Proposal for amendments to the 03 and 04 series of amendments to UN Regulation No. 79

I. Proposal

Model A

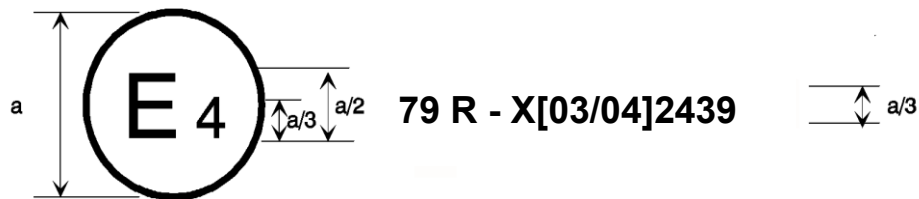
Annex 2, amend to read:

The above approval mark affixed to a vehicle shows that the vehicle type concerned has, with regard to steering equipment, been approved in the Netherlands (E 4) pursuant to UN Regulation No. 79 under approval No. [03/04]2439. The letter “X” preceding the approval number indicates that the vehicle is equipped with ACSF which has been exempted from the requirements of this UN Regulation, and/or that the vehicle is equipped with a steering system which exhibits functionality defined as an ACSF of Category **B2, D or E**. The approval number indicates that the approval was granted in accordance with the requirements of UN Regulation No. 79 incorporating the [03/04] series of amendments.”

Model B

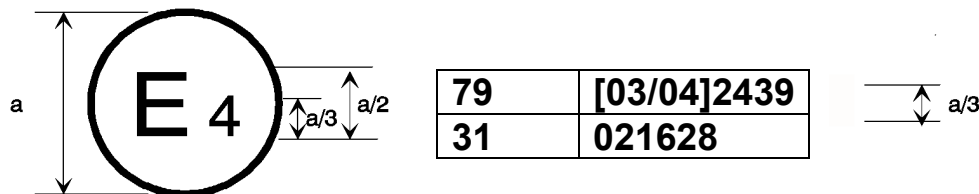
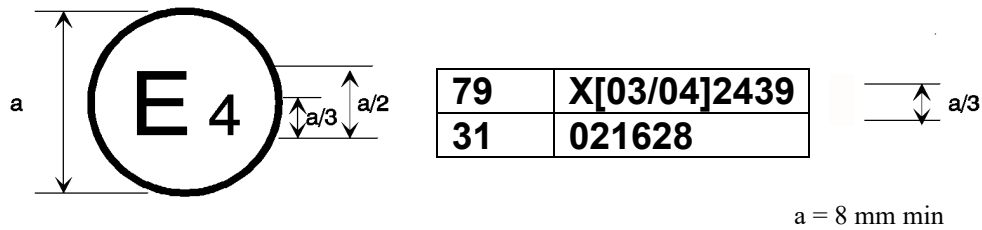
The above approval mark affixed to a vehicle shows that the vehicle type concerned has been approved in the Netherlands (E 4) pursuant to Regulations Nos. 79 and 31.^{B4} The letter “X” preceding the approval number pursuant to Regulation No. 79 indicates that the vehicle is equipped with ACSF which have been exempted from the requirements of this UN Regulation, or that the vehicle is equipped with a steering system which exhibits functionality defined as an ACSF of Category **B2, D or E**. The approval numbers indicate that, at the dates when the respective approvals were given, UN Regulation No. 79 incorporating the [03/04] series of amendments and UN Regulation No. 31 included the 02 series of amendments.”

3. *Paragraph 4.4.3. and Annex 2:* The additional marking provision is updated to also cover ACSF-B2 and E.
4. Because the amendments introduced here are aligned with the amendment of UN Regulation No. 171 to cover these functions, this proposal should be agreed at the same session of GRVA as that amendment.
